# **Submission 3**

This submission supplements my first submission which objects to the Project on the basis that it has the potential to adversely affect the health and well being of children.

# Crystalline Silica and Contaminated Dust Risks and Proximity to Children - Cammeray Major Construction Site for Beaches Link

Figure 22-5 North Sydney precinct landscape character zones and viewpoints

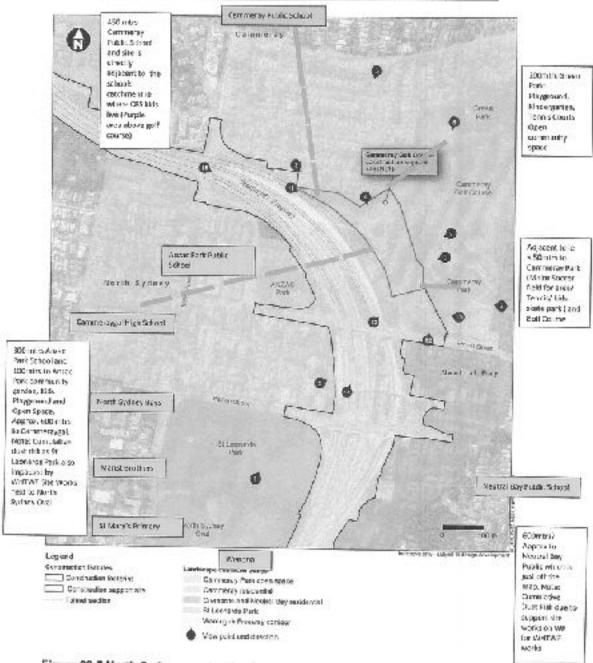
- sports fields where children exercise are adjacent to the construction sites and numerous schools, preschools and child care centres are also in close proximity to the sites less than 500m away: see maps below.

The recommended separation distance between the construction sites (which involves the crushing and stockpiling of rocks potentially producing respirable crystalline silica dust) and sensitive users is not met in this Project - see Maps below. For example, Cammeray Public School, Anzac Park Public School, Shore Oval, Green Park (and the KU Preschool), Cammeray Oval and Tennis Courts, Flat Rock Baseball Diamond, Bicentennial Netball Courts and Ovals are all within 500 metres, and others schools are within 600 metres eg Cammeraygal Public School.
